Product Change Notice (PCN)

PCN Number: PCN-0451184R-01

Product(s) Affected: PJ-050A

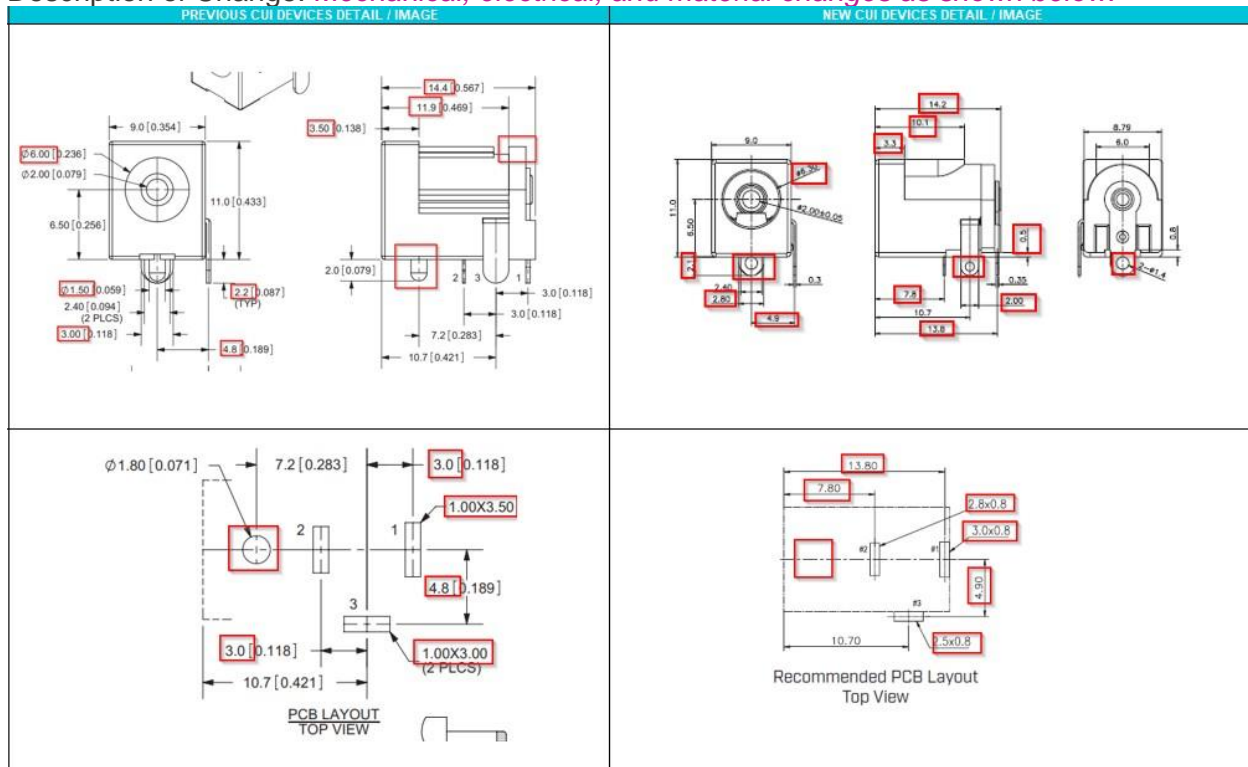
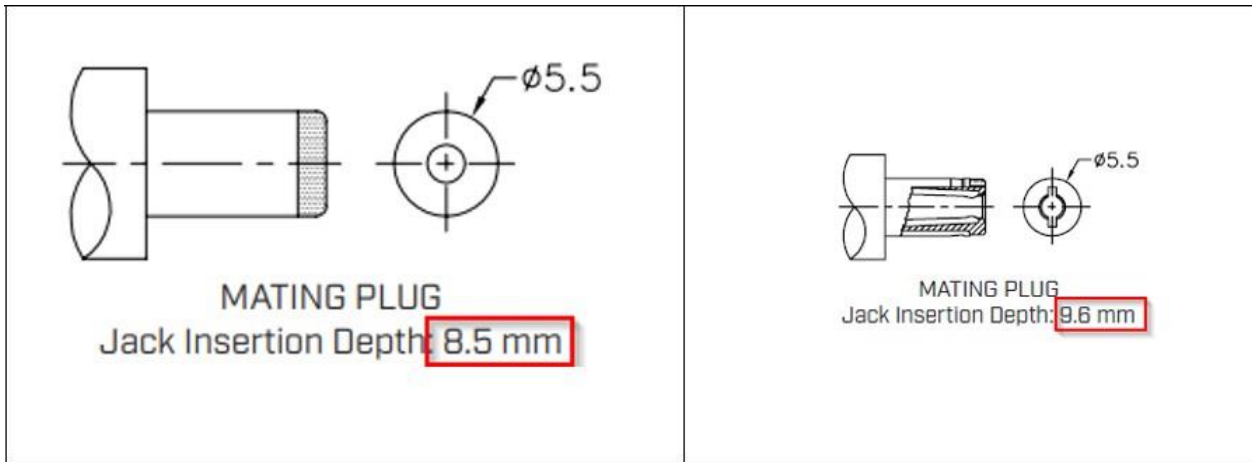
Description of Change: *Mechanical, electrical, and material changes as shown below:*

MATERIAL	PLATING
center pin	copper	nickel
terminal 1	brass	tin
terminal 2	copper alloy	tin
terminal 3	brass	tin
plastic	PBT

DESCRIPTION	MATERIAL	PLATING/COLOR
center pin	copper alloy(H65)	nickel
terminal 1	C2680 t=0.35 mm	nickel-tin
terminal 2	C5210 t=0.25 mm	nickel-tin
terminal 3	C2680 t=0.30 mm	nickel-tin
housing	PA9T (UL94V-0)	black
cover	PA9T (UL94V-0)	black
